**KNOXVILLE HISTORIC ZONING COMMISSION
STAFF REPORT - CERTIFICATE OF APPROPRIATENESS APPLICATION**

PROPERTY ADDRESS: 1 Market Square 37902

FILE NO.: 12-E-18-HZ

LEVEL OF WORK: Level II. Window Replacement (Postponed from the December 20th HZC meeting)

Proposed Oliver Hotel Window Replacement

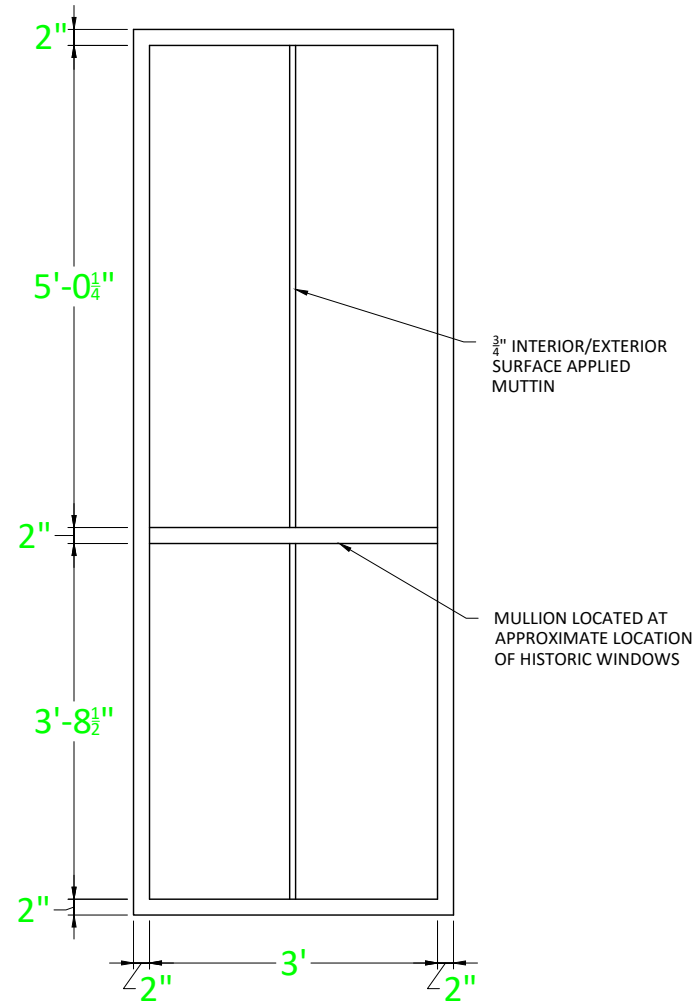
- 1) The building is a contributing building within the Market Square H-1 Overlay and the National Register Historic District.
- 2) The existing windows are single-pane aluminum and are not original and appear to have been installed during the 1960s.
- 3) The proposed windows will have a 2/2 configuration that will match the original windows.
- 4) The original window openings, which are segmentally-arched and have ornamental metal window hoods, are in tact. The replacement windows, which will have square tops, will be mounted behind the openings so that the original openings will still be visible.

7) The guidelines state that replacement windows shall match the size and shape of the original window openings. In this case, the original windows have been removed and the former replacement windows were installed in such a way that the original window opening is maintained and not obscured. Therefore, staff recommends waiving the guideline that the window itself is of the same shape as the original since it will appear to be, as mounted behind the original opening.

Staff recommends approval, with upon further research by the architect, any modifications to the proposal for wood or composite arched frames being approved by staff.
